Product Change Notification

Change Notification #: 115218 - 00

Change Title: Intel® Ethernet Converged Network Adapter XL710-QDA1
Product Code: XL710QDA1G2P5 MM#945035,
Product Code: EXL710QDA1G1P5
MM#943445,
Product Code: XL710QDA1 MM#932583,
Product Code: XL710QDA1BLK MM#932584,
Intel® Ethernet Converged Network Adapter XL710-QDA2,
Product Code: XL710QDA2G2P5 MM#945036,
Product Code: EXL710QDA2G1P5
MM# 943446,
Product Code: XL710QDA2 MM#932586,
Product Code: XL710QDA2BLK MM#932587,
Intel® Ethernet CNA XL710-QSR1
Product Code: XL710QSR1G1P5 MM#950495,
Intel® Ethernet CNA XL710-QSR2
Product Code: XL710QSR2G1P5 MM#950497,
PCN 115218-00, Product Design, Label,
Product Marking, Transport Media
Firmware Update, Box Update

Date of Publication: January 06, 2017

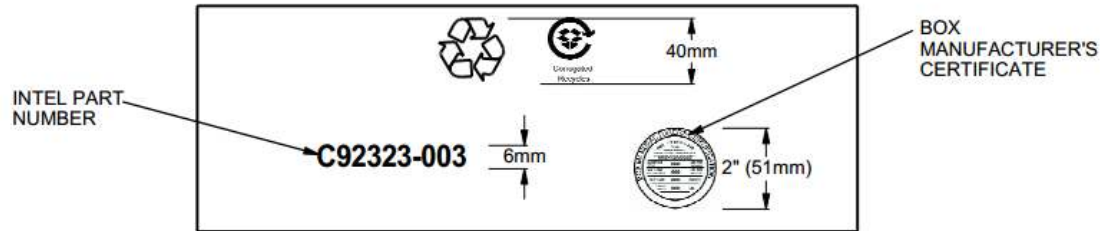
- The outer box is updating to a thicker corrugated lining to help reinforce box strength for shipping. The part number on the box will go from C92323-002 to C92323-003 as shown:
